## Urgent Field Safety Notice (FSN) for FD-8000: Premature wear of brake-arm levers

FD-8000 units sold between 01/01/2015 and 31/12/2017 require an urgent repair to replace the brass levers with steel levers. This instruction explains how to do the repair.

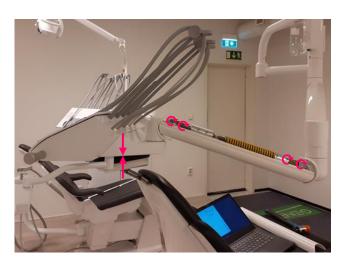
1. Open arm brake cover to expose the levers.
